The Cutaway — Architectural Design Response
iNSW — Rev G — 31/08/23

Project Name	The Cutaway		
Project Code	BCY		
Revision	Date	Comment	Approved
0	31/05/23	Draft Issue	EC
A	06/06/23	Issue for Review	EC
B	07/06/23	Final Issue	EC
C	14/06/23	Final Issue	EC
D	26/06/23	Final Issue	EC
E	21/07/23	Reissue for DPE	EC
F	27/07/23	Reissue for DPE	EC
G	31/08/23	Reissue for DPE	EC
H	08/09/23	Reissue for DPE	EC

Skylights

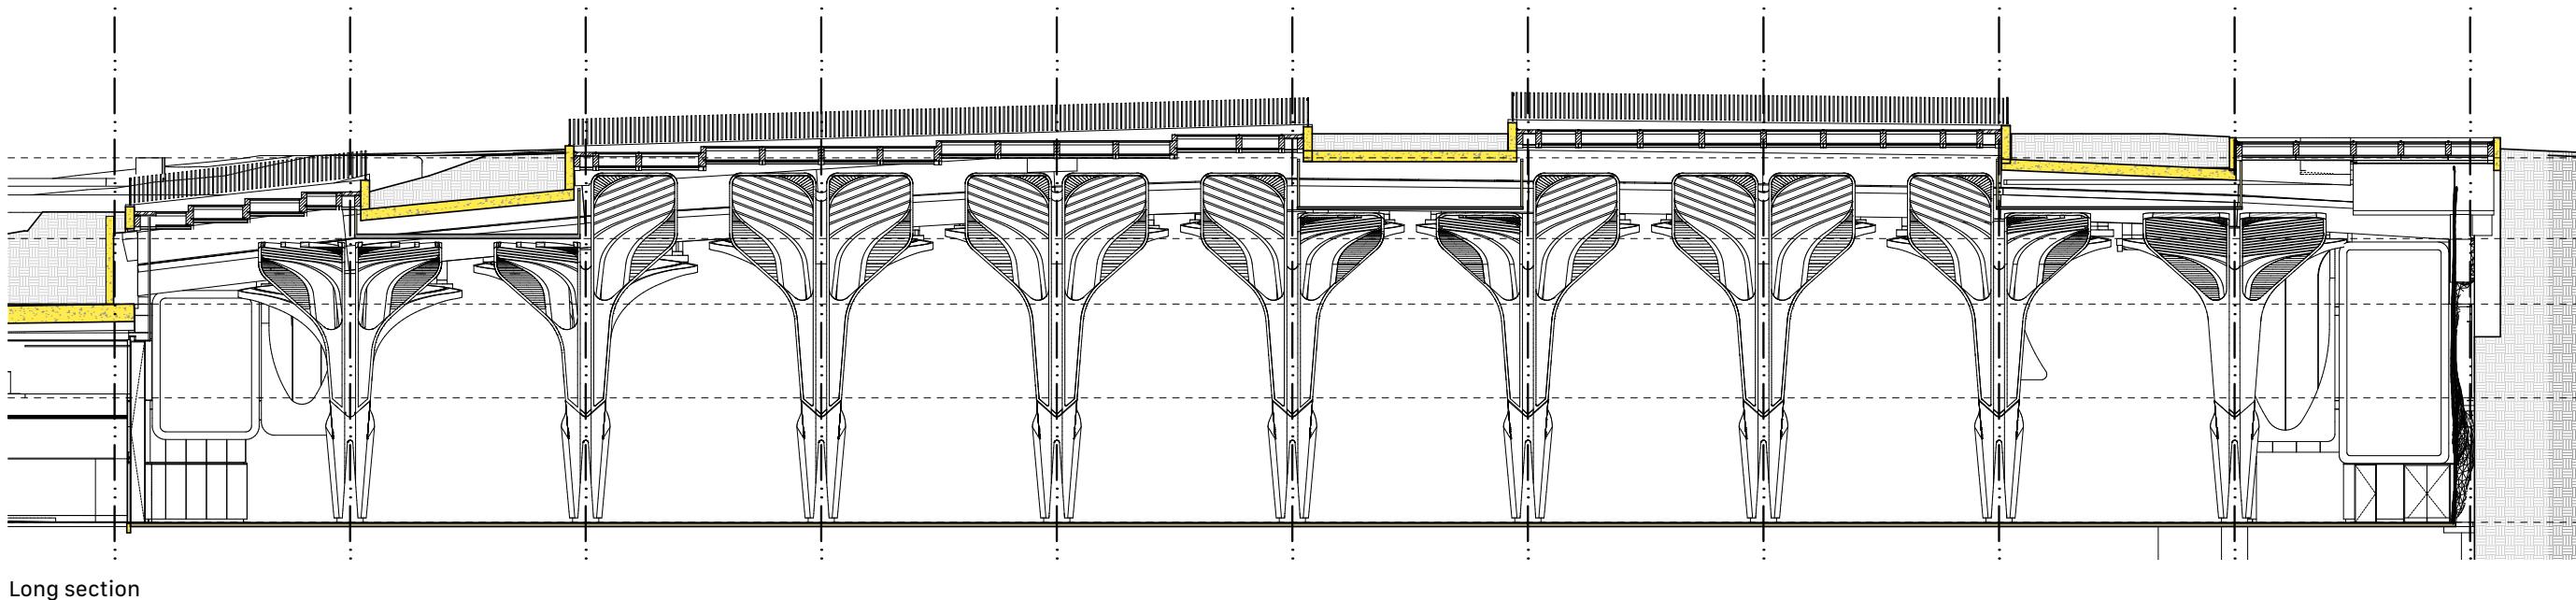
The infill skylights' top surface is to be set no higher than the asphalt surface of Merriman Street to minimise the skylights visual impact on the streetscape and heritage terraces

It is noted that many services are located under the skylights, therefore matters such as waterproofing, visual impact, ventilation, and maintenance must be resolved.

There are no service risers as part of the skylight design that will extend beyond the asphalt of Merriman Street — any services below the skylight internally have been integrated with the architecture. Please refer to the sections on the following page for the developed skylight design.

Strategy

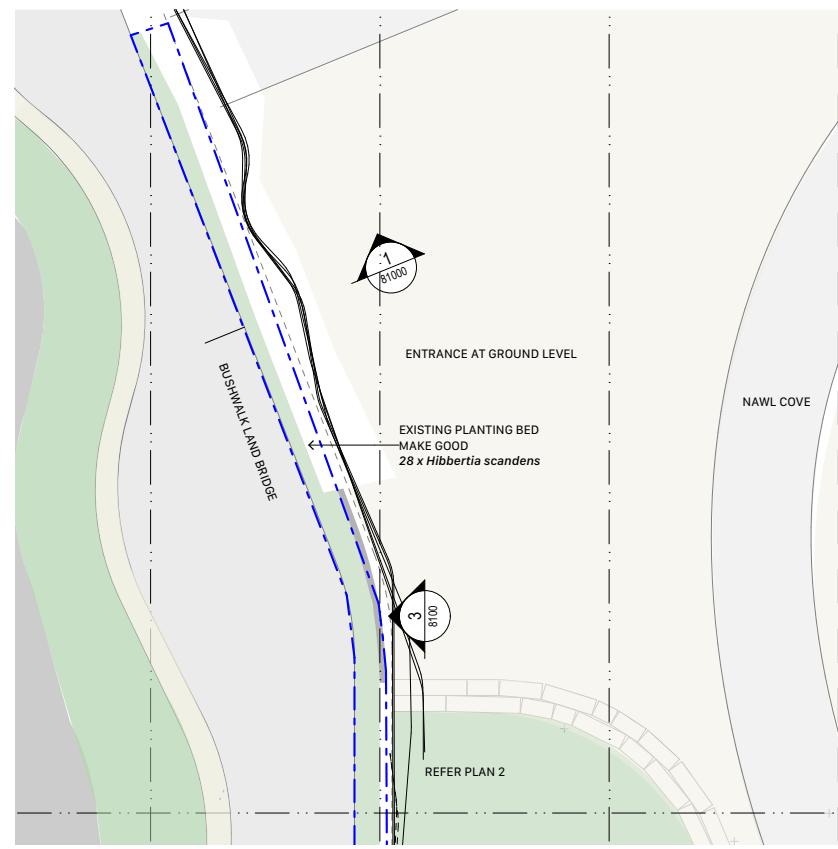
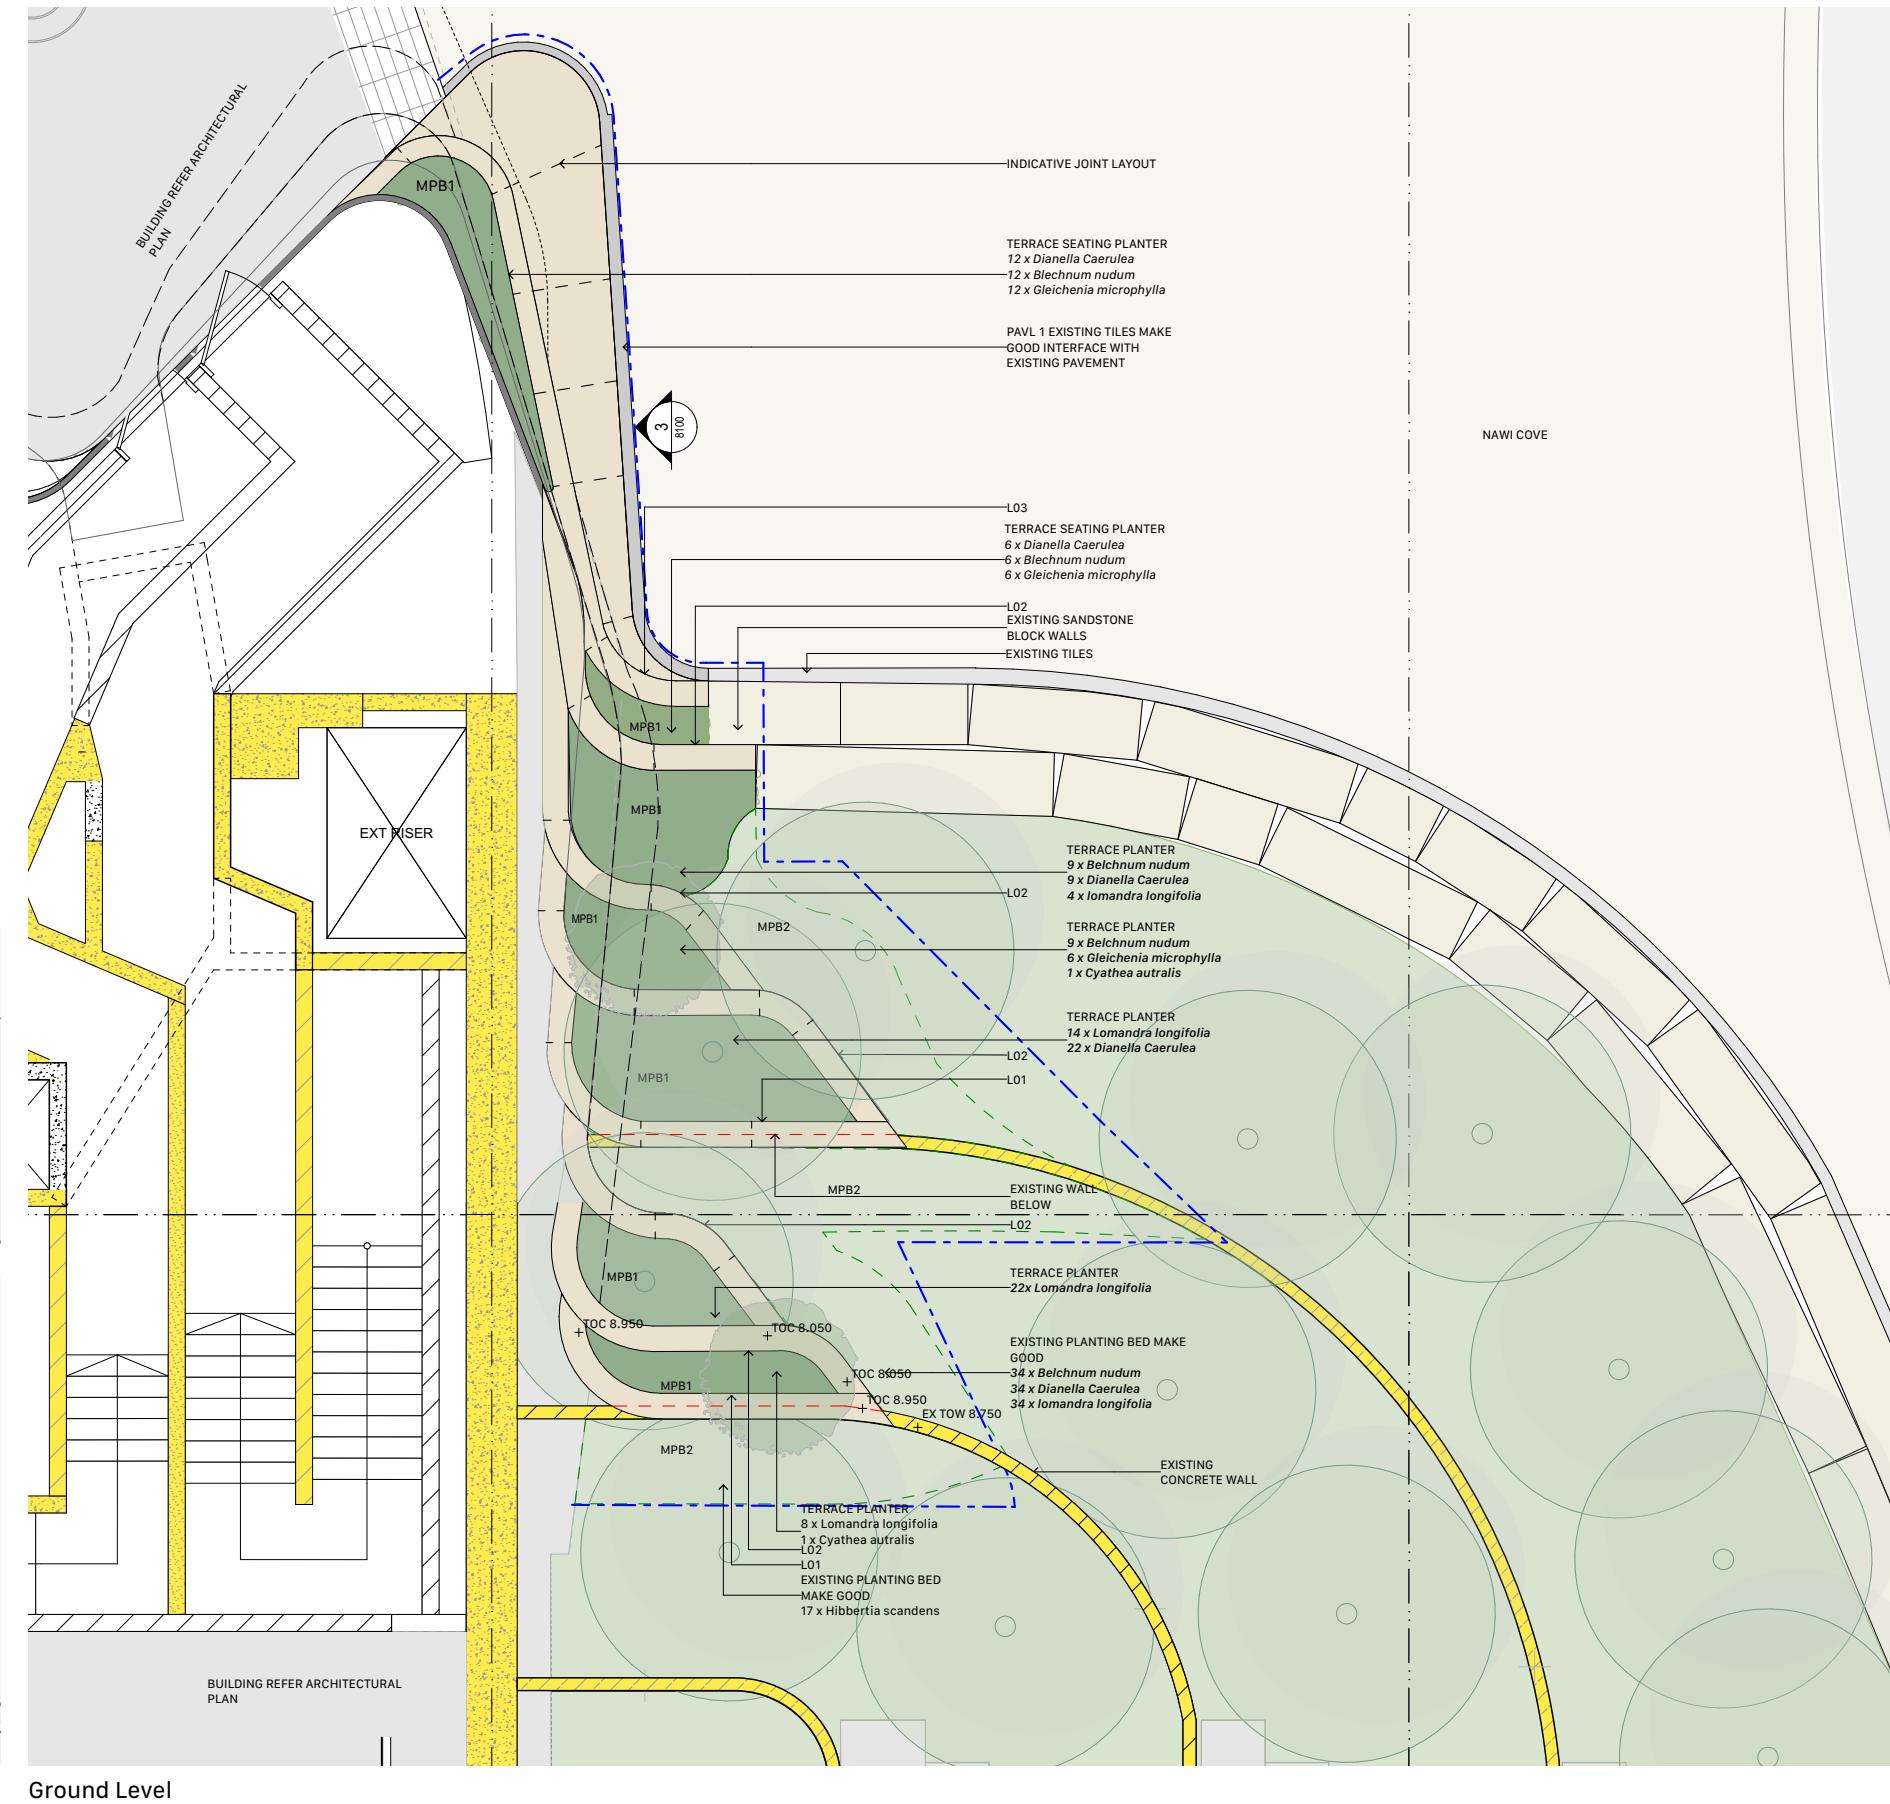
Prepare a detailed landscape plan of the site, showing trees and planting to be removed and new planting proposed.

a. Drawings showing how the curved masonry terraces will terminate in the existing landscaped planter beds.

c. Refine the planting strategy — consider shade tolerant species for the south facing terraces

Provide a landscape plan which denotes any trees and planting that are proposed for removal, replacement planting and where new planting is proposed, including the species type.

There are no landscape plans and there is insufficient information to assess the suitability and feasibility of the landscape works, impacts on existing trees and if the design responds to the site's microclimate, wind impacts and sunlight. There is absent clarity for the extent of works and how the proposal integrates with the existing entrance forecourt to the Cutaway, landscape, walls, and the tiered embankment, and any impacts on trees within the public domain and Barangaroo Reserve (the park). The following is to be addressed.

The landscaping scope is concentrated around the southern entry to the Cutaway and the interface with the existing landscape.

fjandscape have weaved the new cladding elements into the existing terraced embankment, tying in with the existing concrete retaining walls — shown in yellow on the plan. We have carefully considered the transition, and allowed for the soft landscaping to spill over and further soften the area.

The fjandscape team have conducted multiple site inspections to assess the condition of the current planting, and have proposed plants from the existing palette which are currently growing well on the south facing terraced embankment. The proposed species are shade tolerant.

Any trees that need to be removed for the works will be reinstated in their current location.

The landscape works occurring on Level 1 are simply complementing the existing condition, using the same plants that are currently growing in that area.

Details

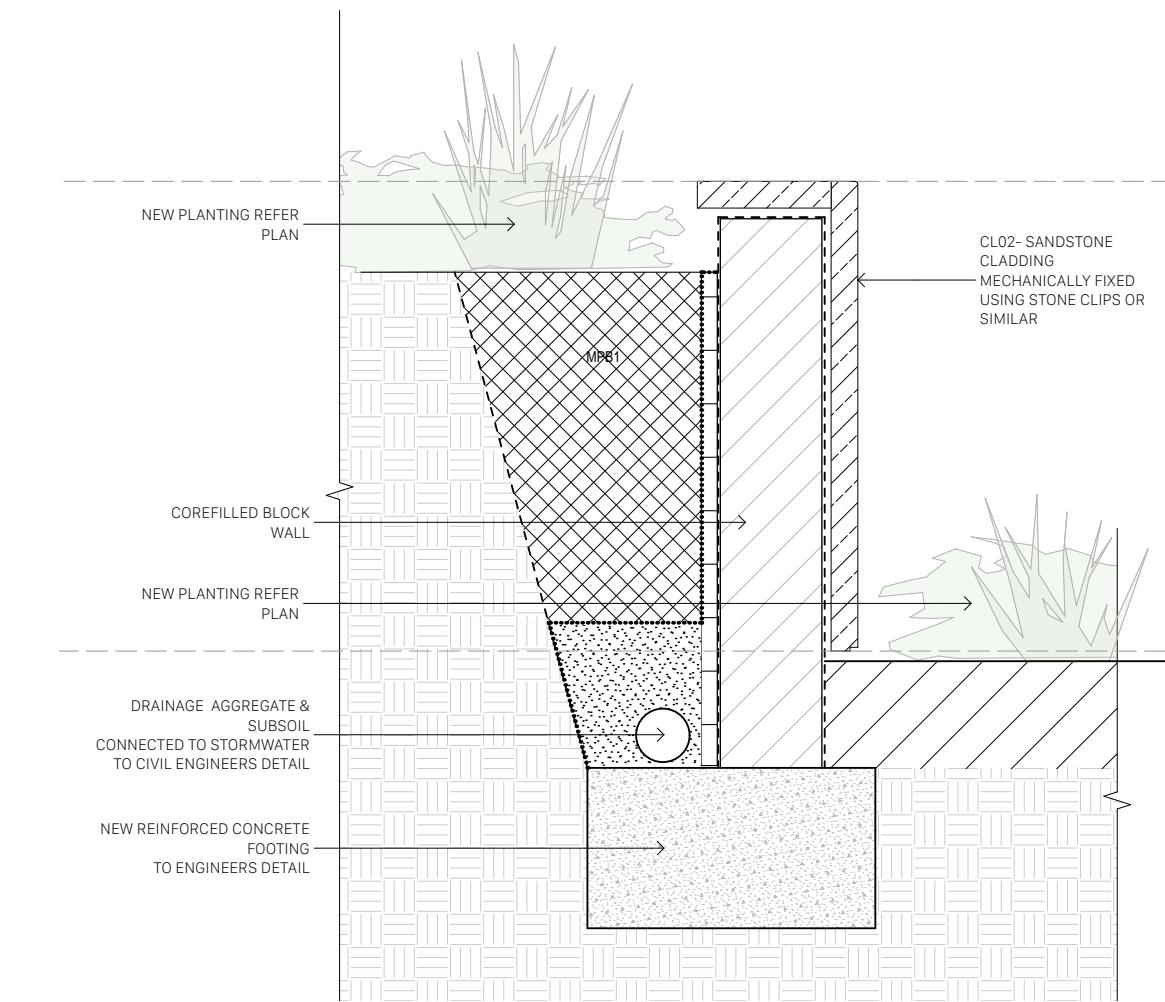
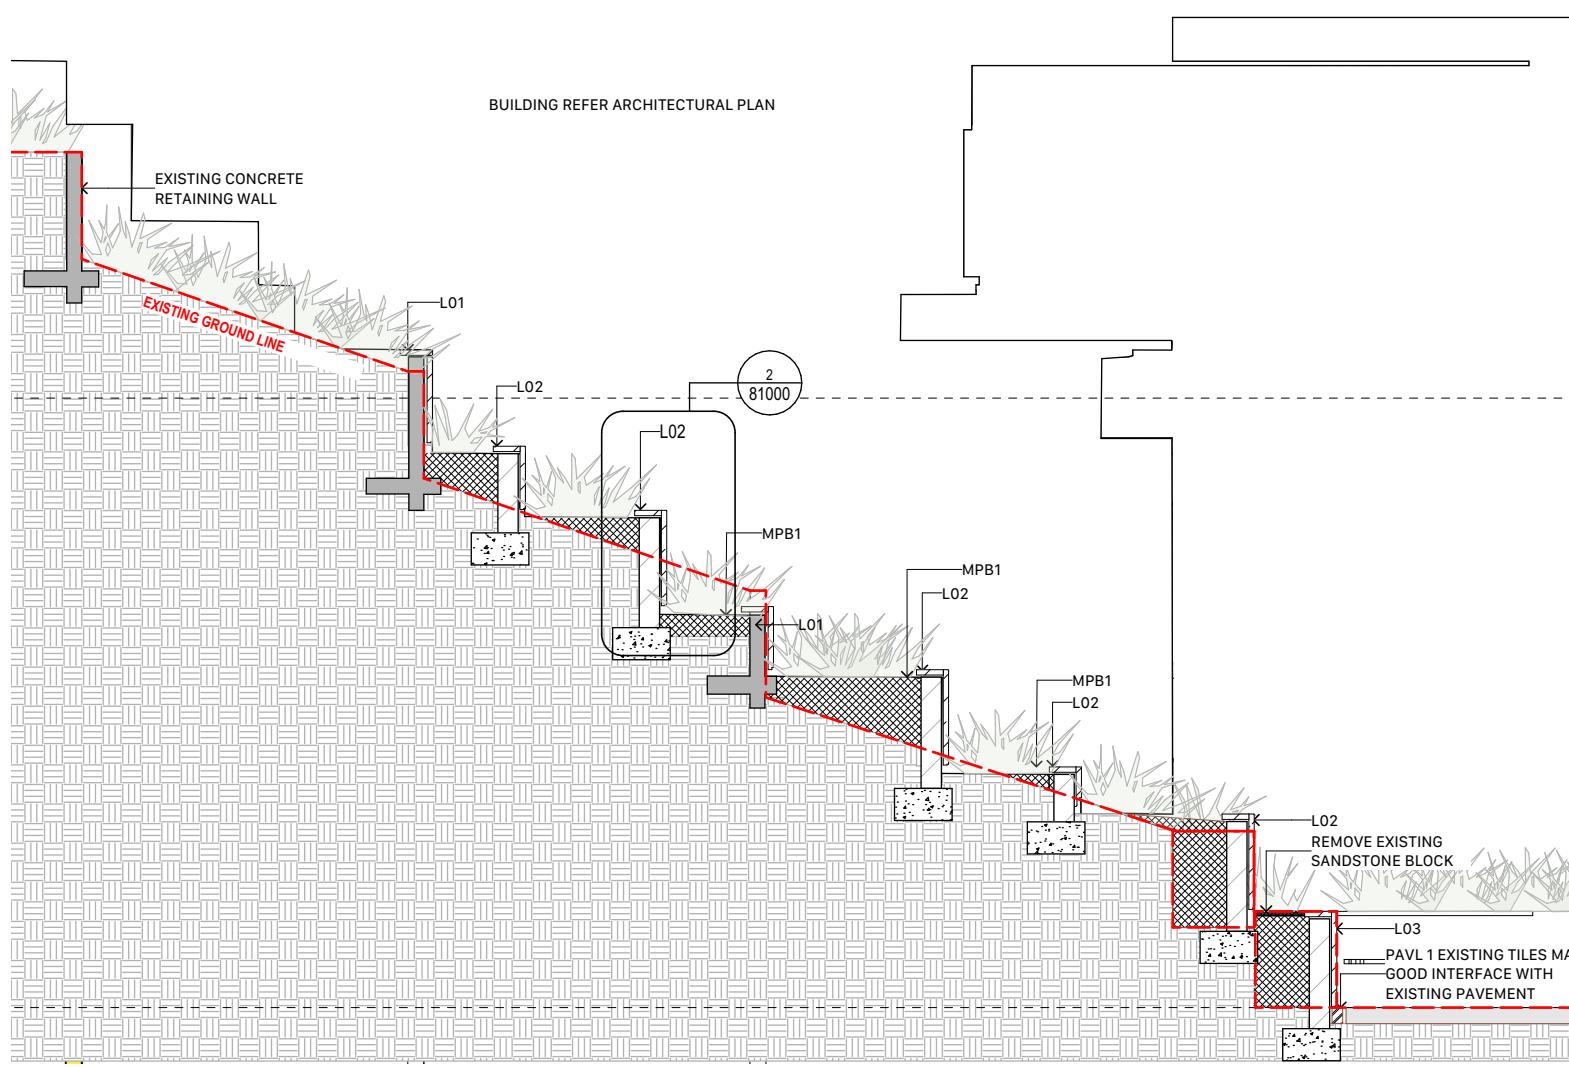
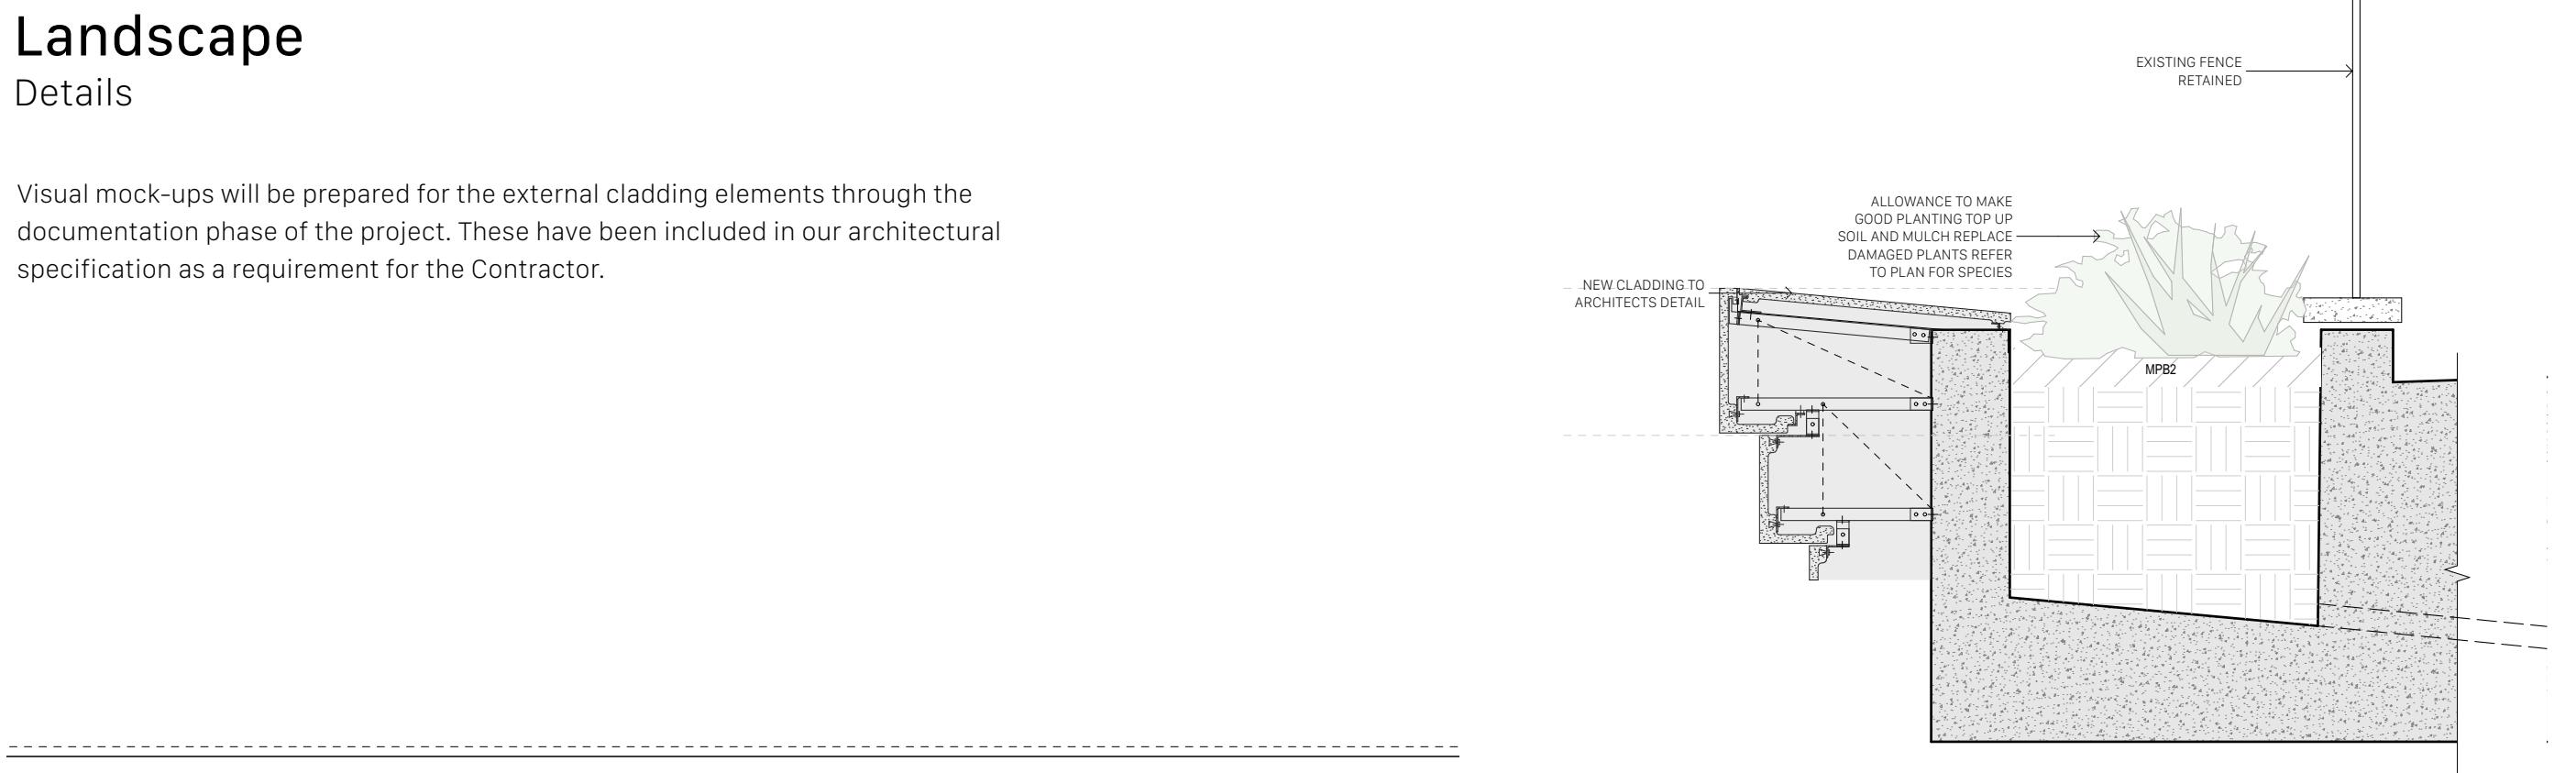
b. indicate which elements are sandstone and which are masonry — detail colours and finishes of all materials

Ensure that visual mock-ups (VMU's) are prepared for the various sculptural elements, including the internal timber and external masonry/GRC entry wall designs.

Visual mock-ups will be prepared for the external cladding elements through the documentation phase of the project. These have been included in our architectural specification as a requirement for the Contractor.
